**From:** [Alison Kennedy](#)  
**To:** [Hayley Smith](#)  
**Cc:** [Abigail Murphy](#)  
**Subject:** RE: South West Rugby Design Code  
**Date:** 27 May 2025 12:31:01  
**Attachments:** [image001.png](#)  
[image002.png](#)  
[image003.png](#)  
[image004.png](#)  
[image005.png](#)  
[image006.png](#)

**The Town and Country Planning (Local Planning) (England) Regulations 2012  
South West Rugby Design Code Supplementary Planning Document public  
consultation**

Catesby Estates' Consultation Response Table to the South West Rugby Design Code SPD (February 2025)

Design example A: Secondary street in urban residential or mixed use context.

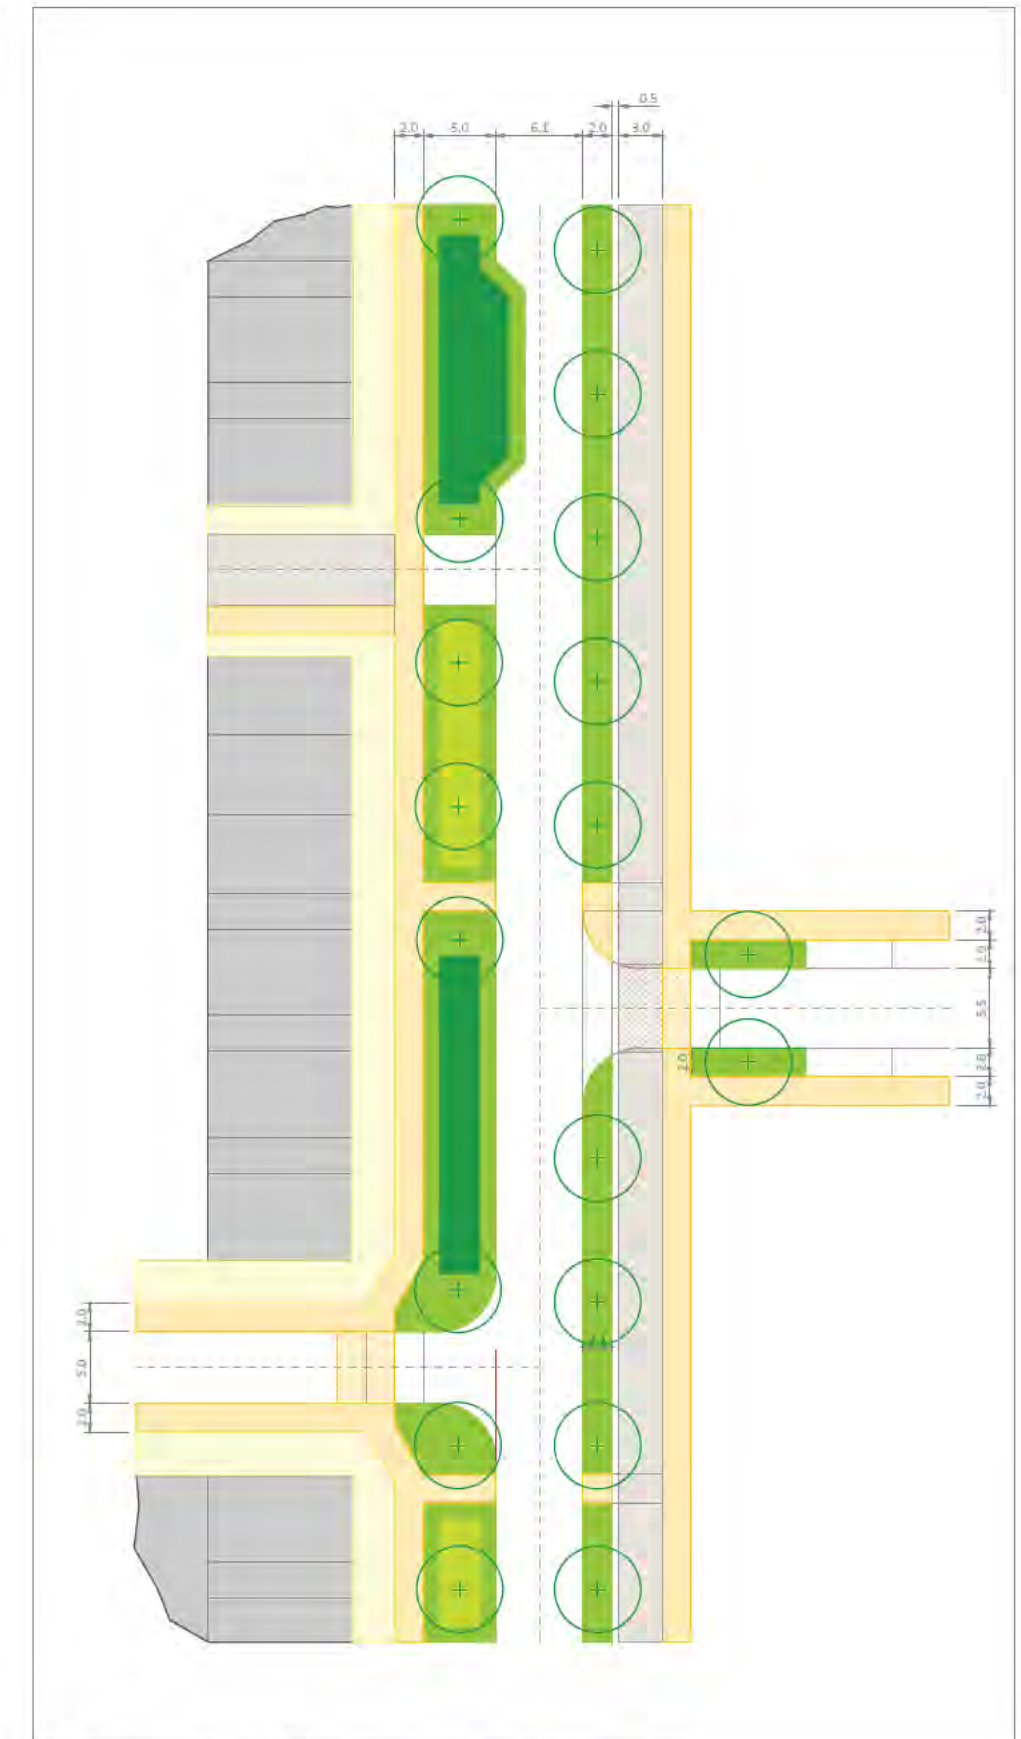
- p57 Example A doesn't need 0.5m buffer except next to parking, Example D doesn't need 0.5m buffer
- p59 Tertiary Street change text to 'safe cycling must be accommodated in the carriageway unless the street includes schools or community facilities, or provides a short link between cycle tracks, in which case cycle tracks should be provided'

- p57 Example A doesn't need 0.5m buffer except next to parking, Example D doesn't need 0.5m buffer
- p59 Tertiary Street change text to 'safe cycling must be accommodated in the carriageway unless the street includes schools or community facilities, or provides a short link between cycle tracks, in which case cycle tracks should be provided'
